**Submitted by the Chair of the Group of Experts on Road Signs and
Signals and Secretariat**

This document contains the final report of the Group of Experts on Road Signs and Signals as well as comments (displayed in the margin) provided by several countries, possible responses as well as conclusions already reached by WP.1 at the March 2020 session. WP.1 will be invited to continue discussing this document.

ECE/TRANS/WP.1/2019/4

Final report

A, 29 a; A, 29 b and A, 29 c “ADDITIONAL SIGNS AT APPROACHES TO LEVEL-CROSSINGS OR SWING BRIDGES”

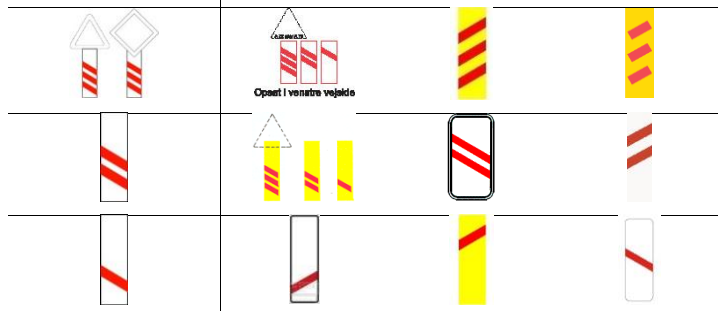
The Group noted that one country (Sweden) uses the panel that appears not to be in conformity with the Convention.

The Group recommended to reproduce the images of signs for both sides of the carriageway.

The Group believes, in terms of visibility, that the bars (one, two or three) be placed in the upper part of the panels (ref. to the sign from Finland) or preferably centred on the panels. The Group recommended including the preferred variant on the images reproduced in the Convention.

B, 5 “PRIORITY FOR ONCOMING TRAFFIC”

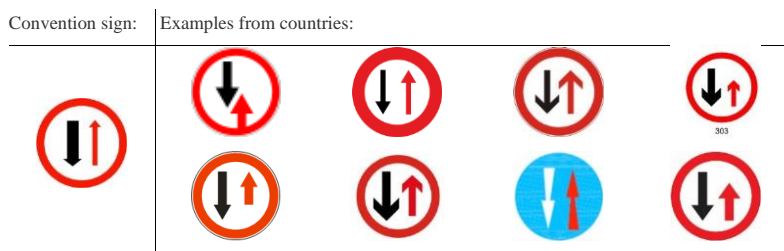
The Group noted that some countries do not use the arrows (i.e. length, width, positioning) as they appear in the Convention. Addressed in in chapter 1 – see issue 11, 12, 35 and 37

Contracting Parties should note the recommendation for this sign in section 1.2 of this document.

C, 13 ba “OVERTAKING BY GOODS VEHICLES PROHIBITED”

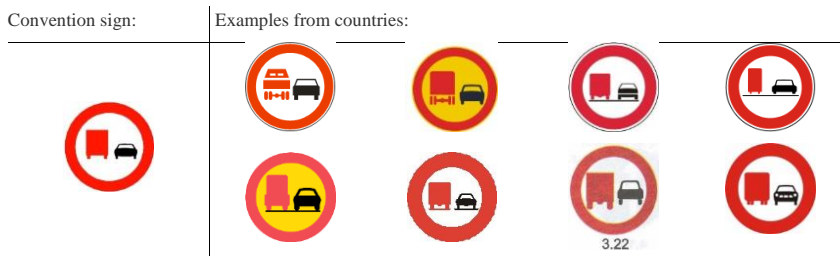
The Group noted that some countries use symbols for the vehicles different than in the Convention. One country (Slovakia) uses a very narrow symbol for the truck vehicle. Some other countries (Bosnia and Herzegovina, Montenegro and Serbia) use a truck vehicle symbol that does not resemble a truck vehicle of the Convention. One country (Vietnam) puts a front image of the vehicle, which does not indicate the overtaking manoeuvre. One country (Uzbekistan) does not align the vehicle symbols horizontally. Again, some countries include a line on the sign illustrating a pavement.

The Group recommended that no line illustrating the pavement should be included in the sign. The Group also recommended that countries should pay more attention to the design details and ensure that the vehicle symbols resemble that of the Convention.

C, 13 bb “OVERTAKING BY GOODS VEHICLES PROHIBITED”

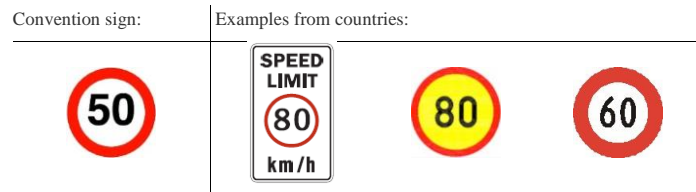
The Group noted that one country (Kuwait) uses the oblique bar over the truck vehicle symbol and not placed in the middle of the sign.

The Group recommended Kuwait not to use this sign, especially that Kuwait uses the C, 13^{ba} sign too. As per Article 5, para 2 (a) of the Convention a Contracting Party should adopt only one of these signs.

C, 18 “PARKING PROHIBITED”, C, 19 “STANDING AND PARKING PROHIBITED”

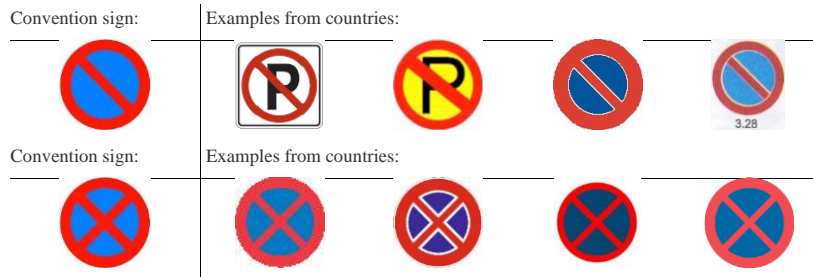
The Group noted some visual differences in the width of the border of the red circle (also in proportion to the width of the oblique bar), and differences in the shade of the blue colour as well as the use of white separation within the sign and a sign’s white external rim (essentially done to increase the discrimination between the colours used in the sign as well as the sign and its environment). The Group believed that the essential characteristics of the sign have been retained.

The Group noted that one country (Uzbekistan) separated the red oblique bar(s) from the red border of the sign.

Addressed in chapter 1 – issue 7, 12 and 19

E, 18 a “STOPPING PLACE IN CASE OF EMERGENCY OR DANGER”

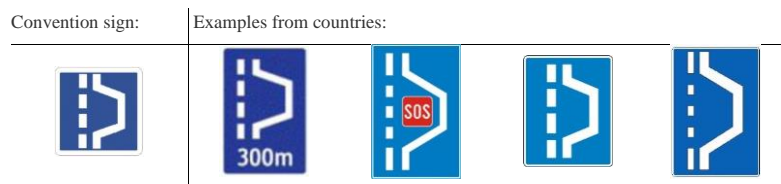
The Group noted that some countries (Croatia and Norway) included the inscription S.O.S in the sign. Placing the S.O.S inscription the Group considers to be in conformity with the Convention. Placing the inscription within a red square on the sign (Croatia) is however considered not to be in Conformity with the Convention.

E, 18 b “STOPPING PLACE IN CASE OF EMERGENCY OR DANGER”

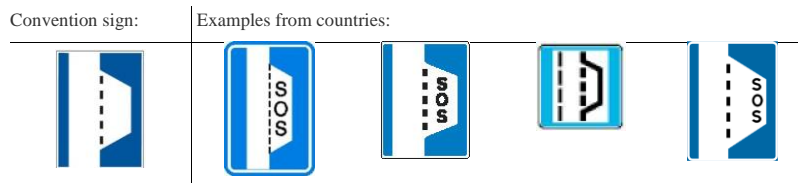
The Group noted that some countries (Belgium, Denmark, Finland, Netherlands, Portugal, Sweden and Switzerland) included the inscription S.O.S in the sign, which the Group considers to be in conformity with the Convention. The sign from Serbia contains the inscription S.O.S on the red square, which the Group considers not to be in conformity with the Convention.

The Group also noted that the sign from Germany has a different design, which appears to be a combination of E, 18 a and E, 18 b designs, which is considered not to be in conformity with the Convention.
